CITY OF ALBUQUERQUE

Re: Phase II Alteration Level 2
3100 Menaul NE
Traffic Circulation Layout
Architect's Stamp 02-20-20 (H16-D153)

Based upon the information provided in your submittal received 02-20-20, the above referenced plan cannot be approved for Building Permit until the following comments are addressed:

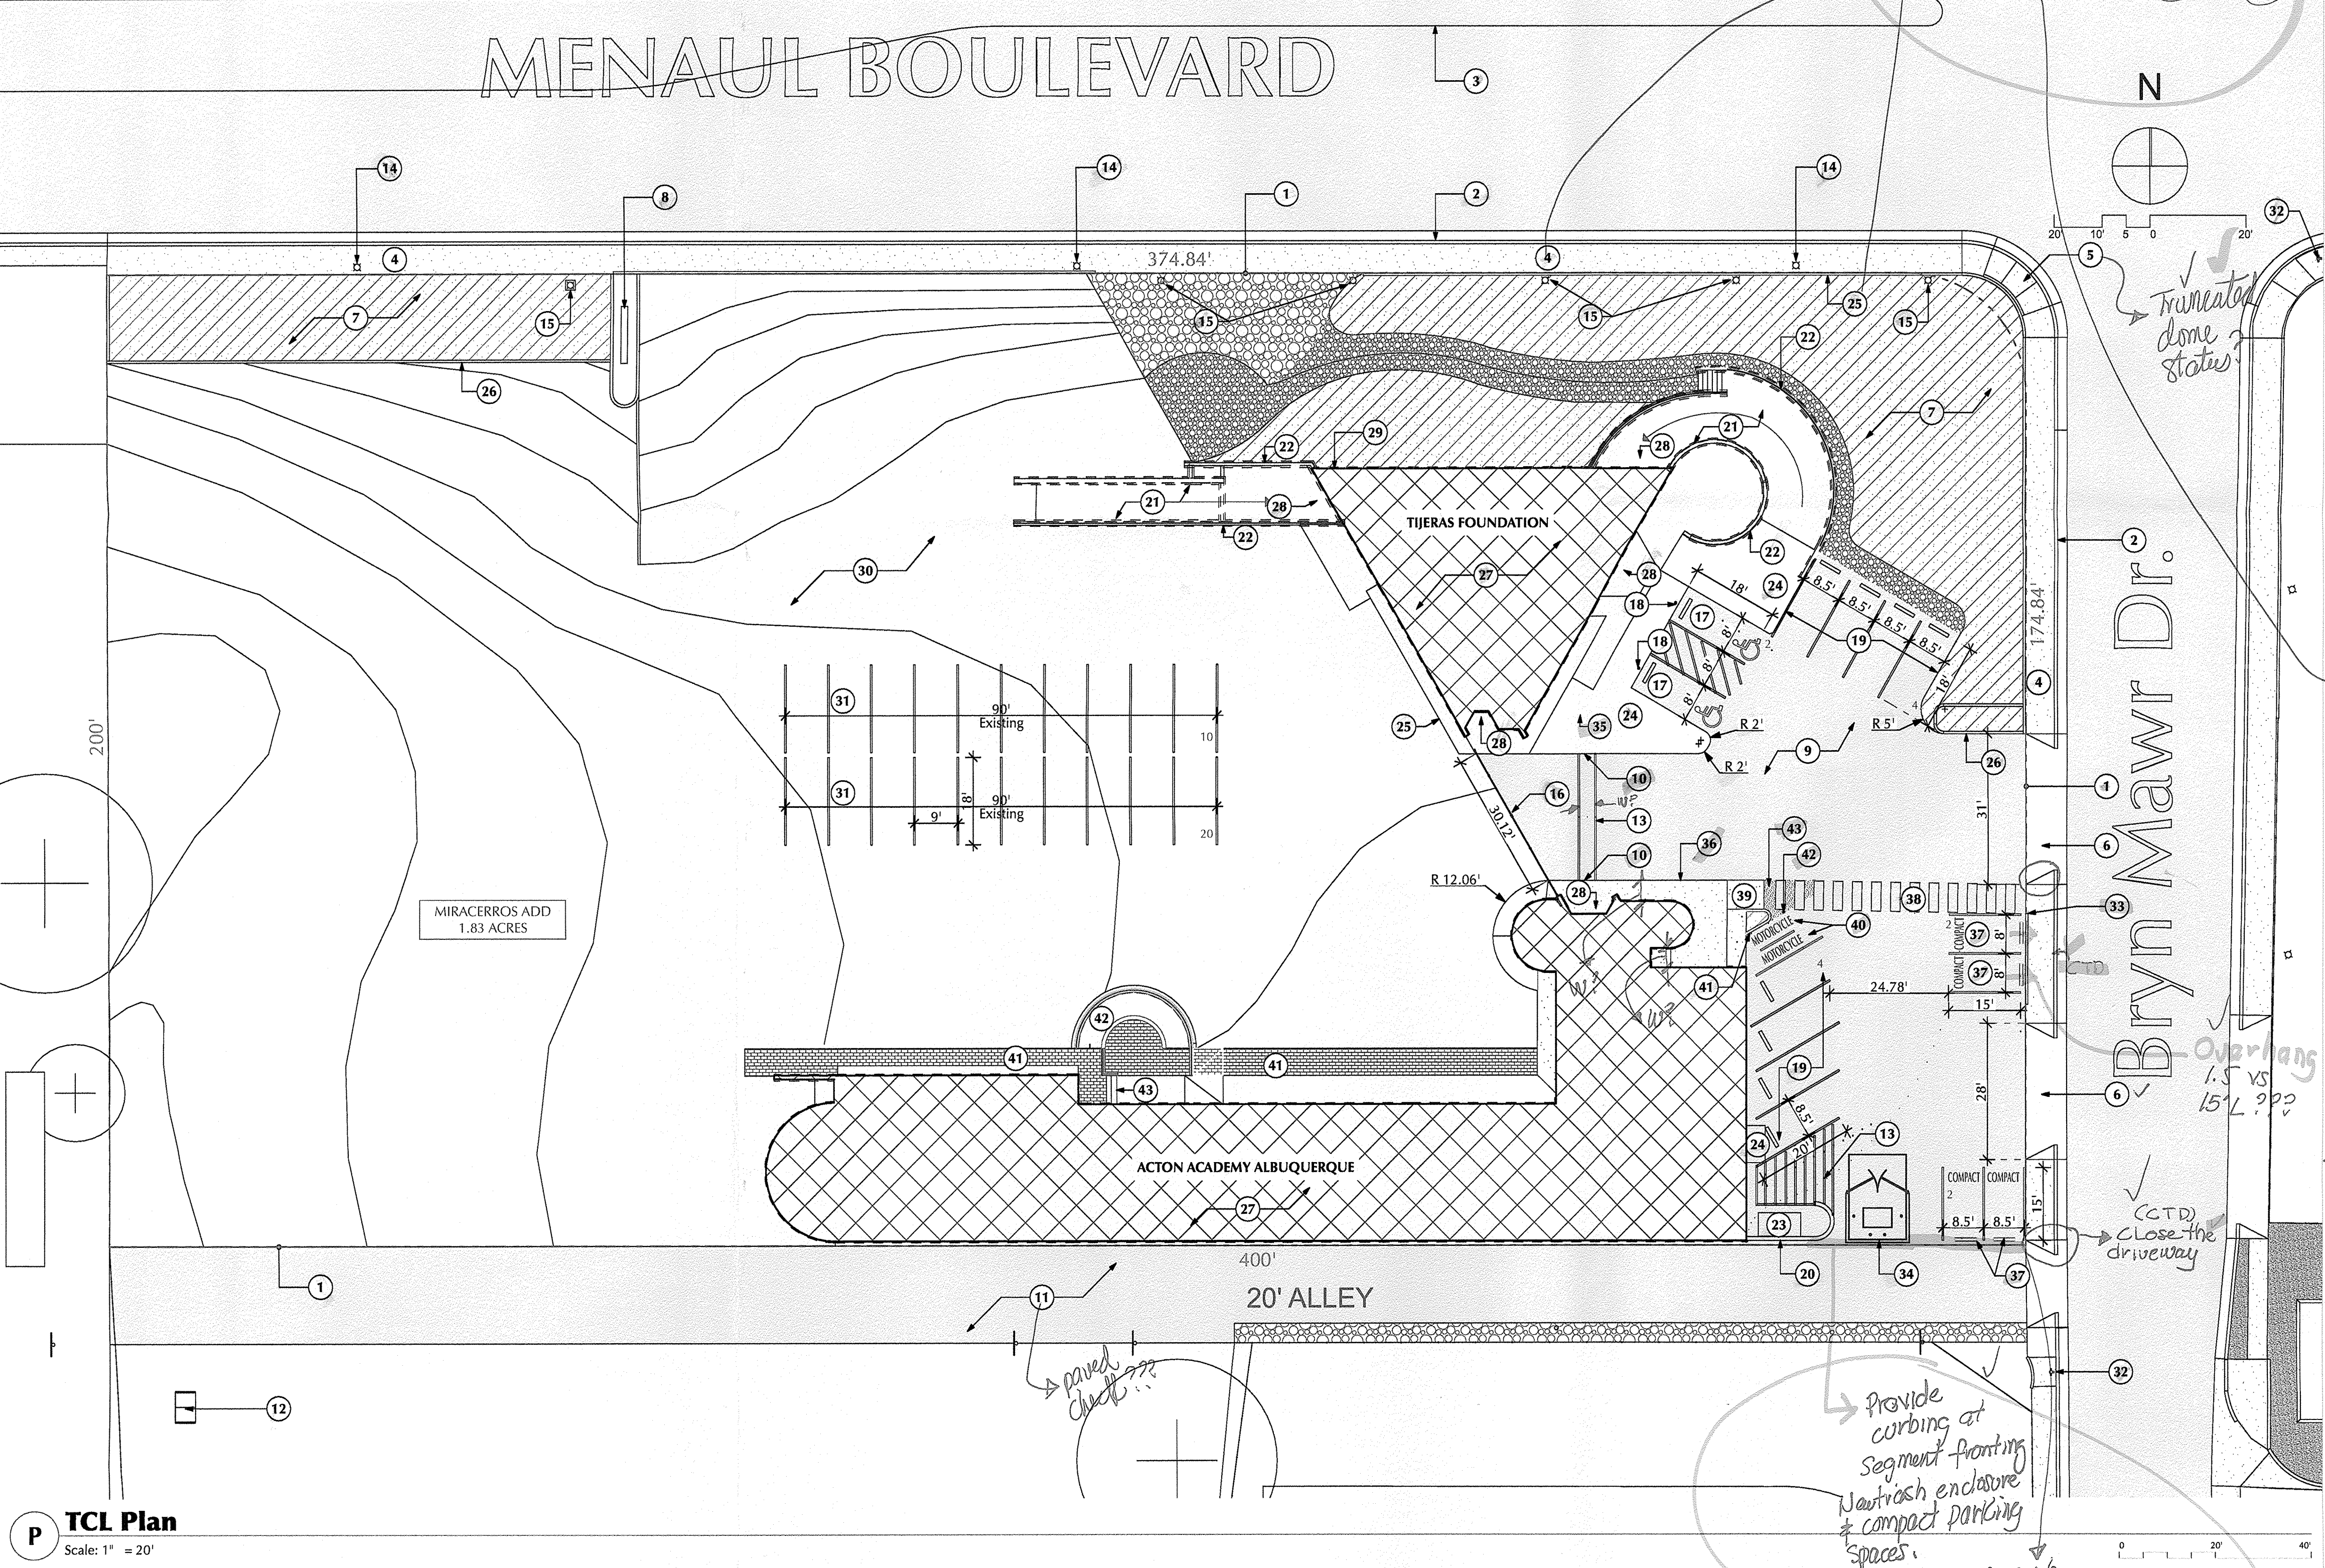
2. ADA curb ramps must be updated to current standards and have truncated domes installed (corner of Menaul/Bryn Mawr).
3. Motorcycle parking spaces shall be designated by its own conspicuously posted upright sign, either free-standing or wall mounted per the zoning code.
4. All bicycle racks shall be designed according to the following guidelines:
 - a. The rack shall be a minimum 30 inches tall and 18 inches wide.
 - b. The bicycle frame shall be supported horizontally at two or more places. Comb/toaster racks are not allowed.
 - c. The rack shall be designed to support the bicycle in an upright position. See the IDO for additional information.
 - d. The rack allows varying bicycle frame sizes and styles to be attached.
 - e. The user is not required to lift the bicycle onto the bicycle rack.

- f. Each bicycle parking space is accessible without moving another bicycle.
- 5. A 5 ft. keyway is required for dead-end parking aisles.
- 6. Per the IDO, a 6 ft. wide ADA accessible pedestrian pathway is required from the public sidewalk to the building entrances. Please clearly show this pathway and provide details.

- 7. ADA accessible pedestrian pathway should not be placed behind parking space or adjacent to a vehicular way. Vehicle and pedestrian/wheel chair conflicts should be avoided as much as possible.

- 8. All sidewalk along Menaul specifies two widths dimensions. Please clarify the key notes 4 and 25.
- 9. Curbing should be installed to delineate landscape, parking, and pedestrian ways and identify points of access. Please call out detail and location of barrier curb along segment of 20 ft. Alley, new trash enclosure, and proposed compact parking spaces(2).

- 10. Parking areas shall have barriers to prevent vehicles from extending over public sidewalk, public right-of-way, or abutting lots. Please verify the compact parking spaces (2) fronting Bryn Mawr.

- 11. Please specify the City Standard Drawing Number when applicable.
- 12. Unused curb cuts must be replaced with sidewalk and curb & gutter(2 unused driveways shown off Bryn Mawr). A build note must be provided referring to the appropriate City Standard drawing.

- 13. Add a note stating "All broken or cracked sidewalk must be replaced with sidewalk and curb & gutter." A build note must be provided referring to the appropriate City Standard drawing.

- 15. Key Notes 10, 33 and 42 will need details.

02-20-2020	
Phase II Alteration Level 2 3100 Menaul NE Albuquerque • New Mexico • 87107	
Acton 3100 Menaul NE Albuquerque • New Mexico • 87107	
James C Lewis 505-247-1529 gdi@mac.com	
Site Details	
SHEET C-501 DECEMBER 2019

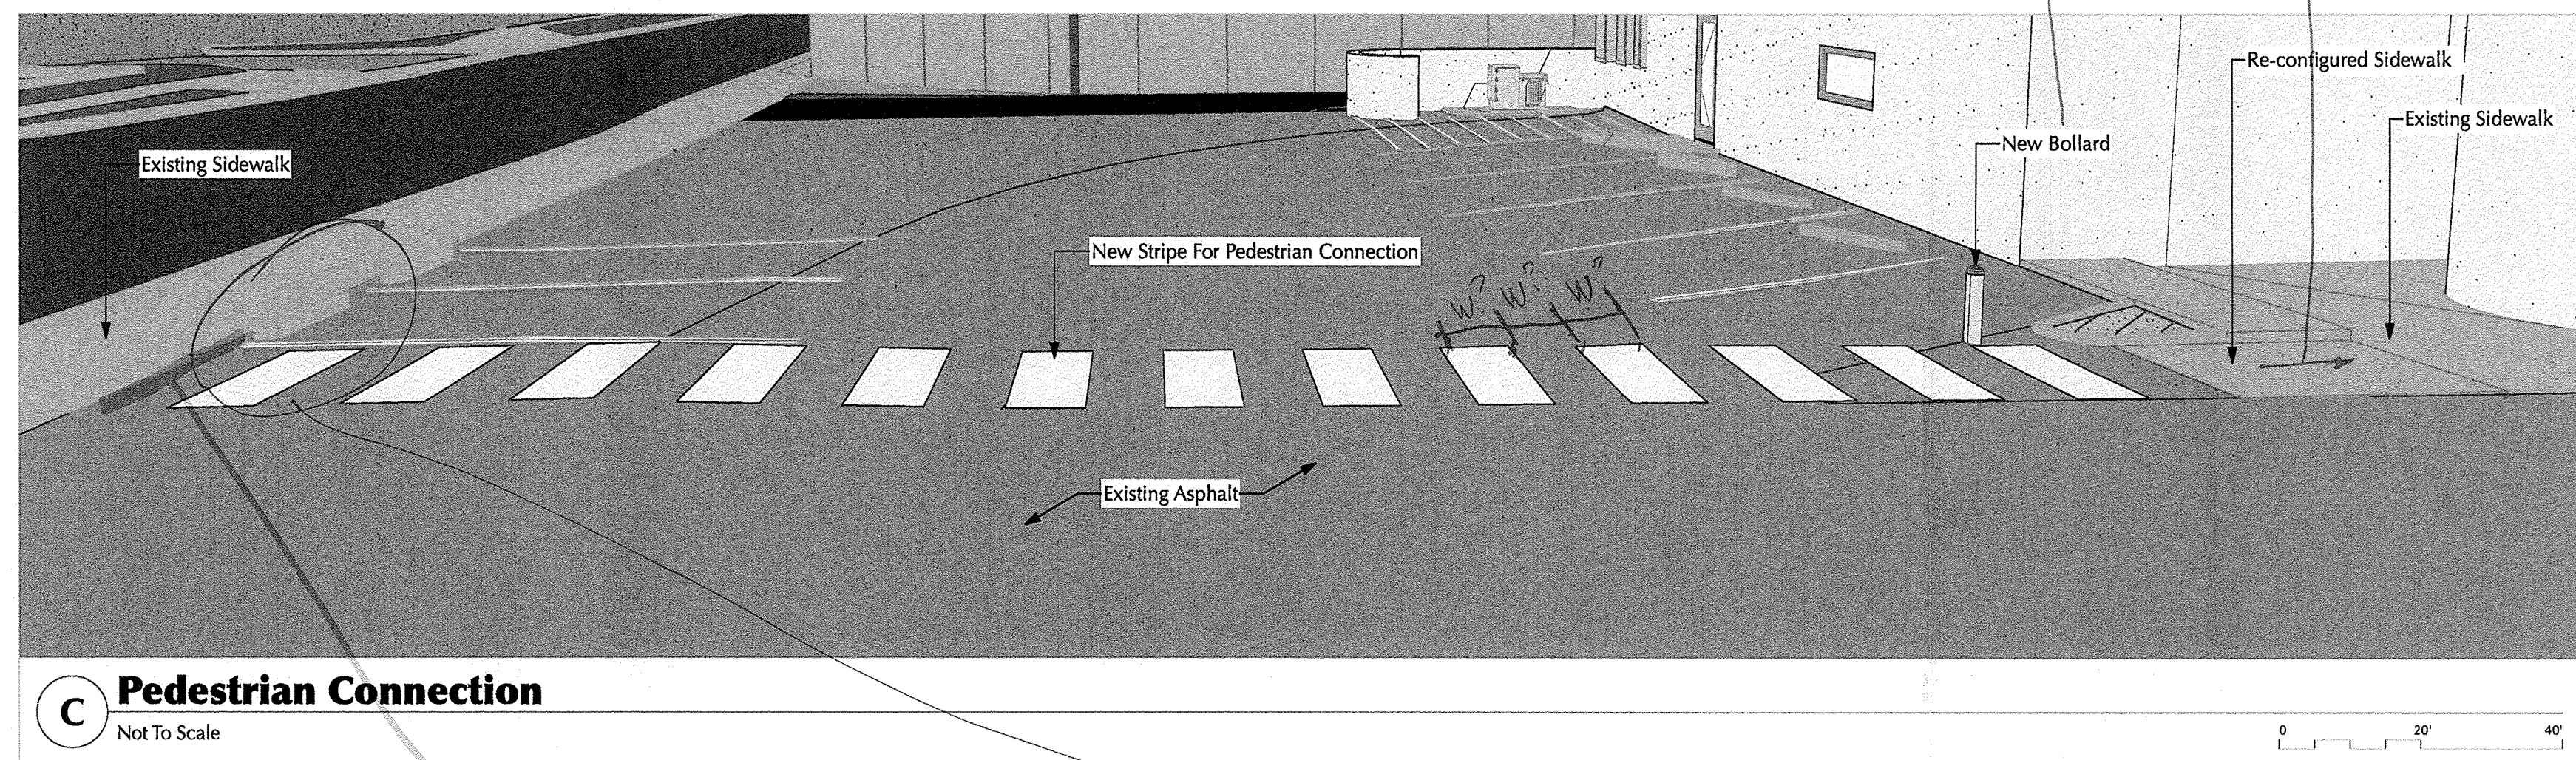
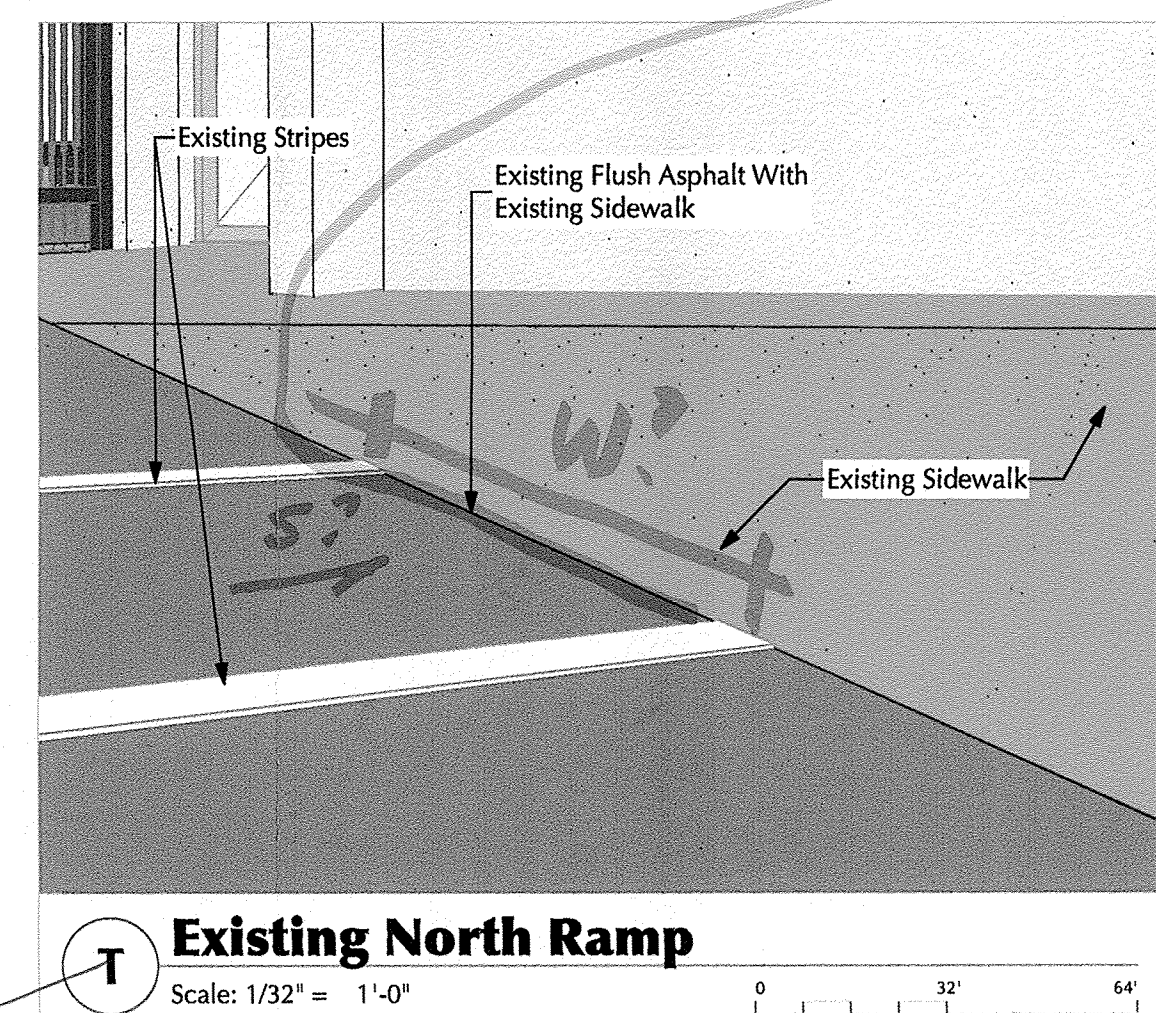
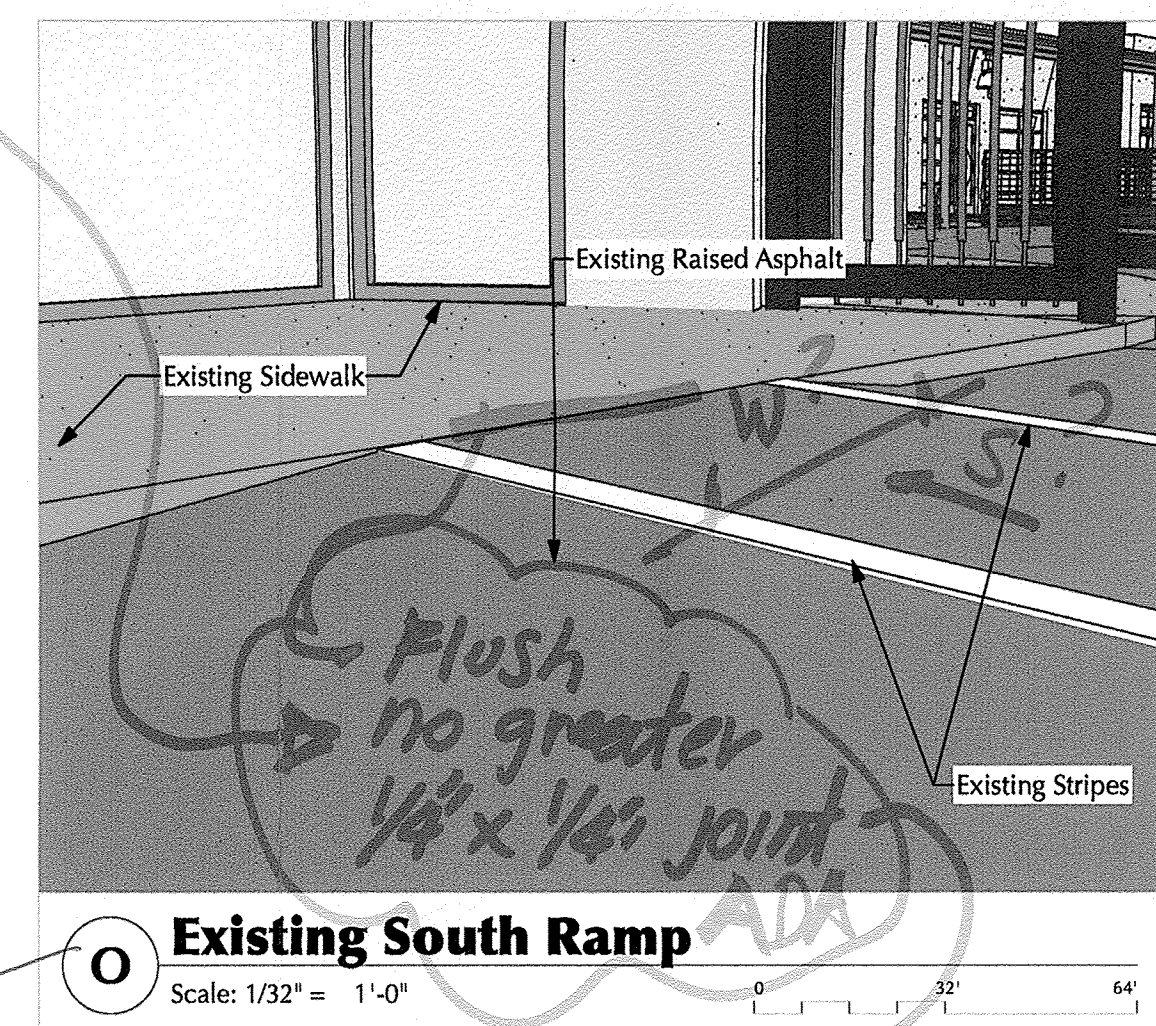
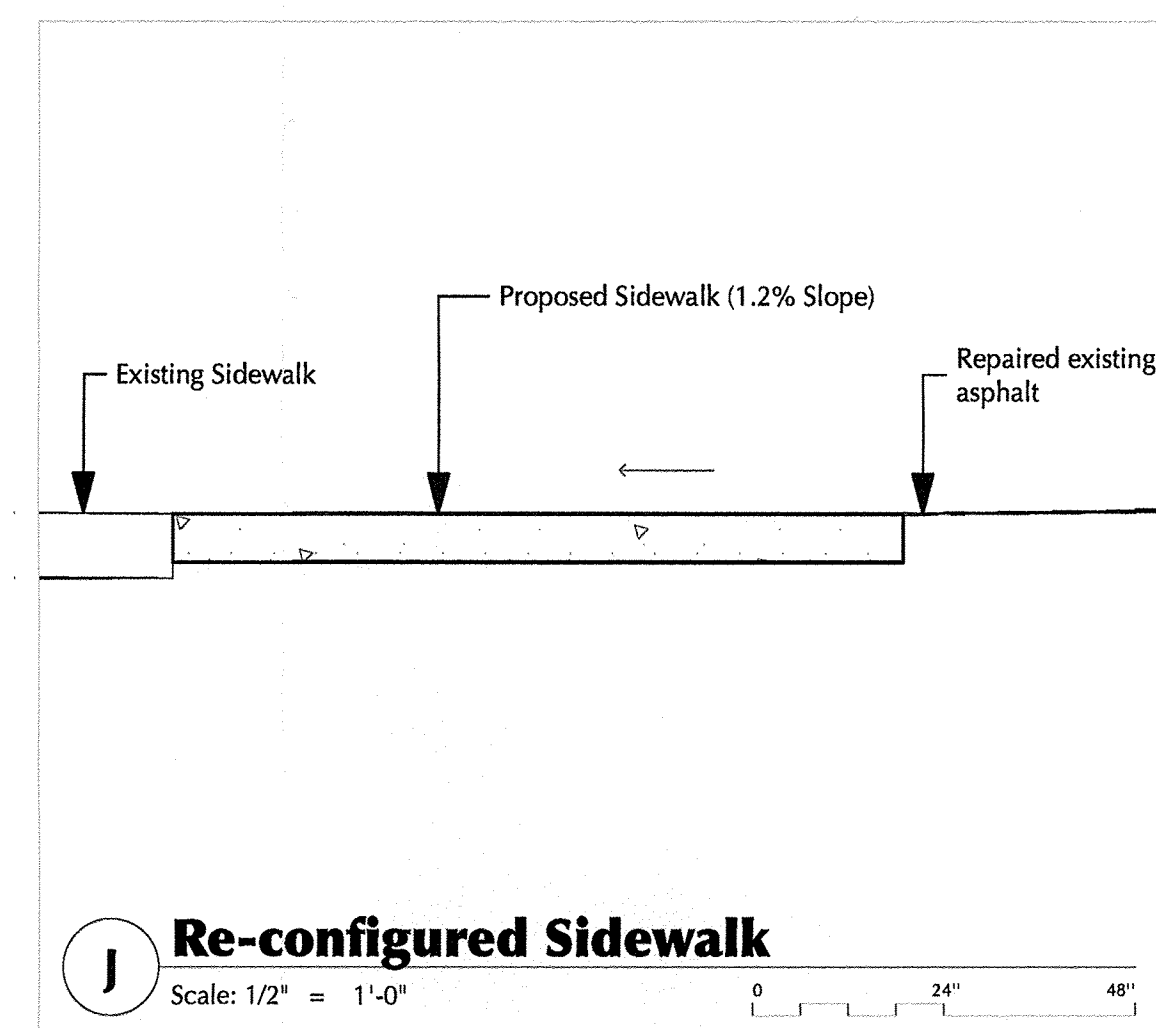
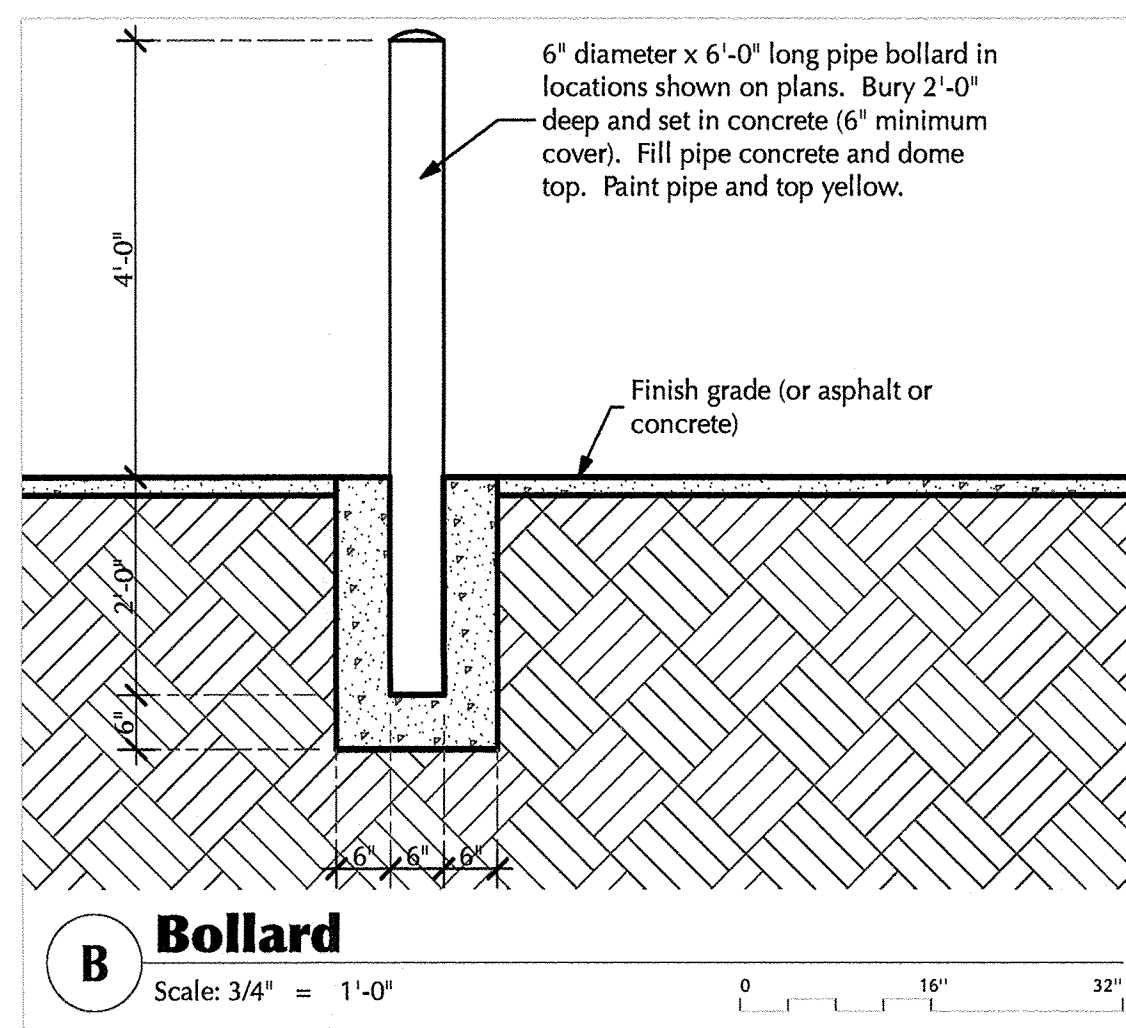
- 14. Provide more detail, on sheet C-501 (Detail C,O and T) and sheet C-102(Key Note 43), to ensure that proposed pedestrian path connection onto existing sidewalk is ADA accessible.
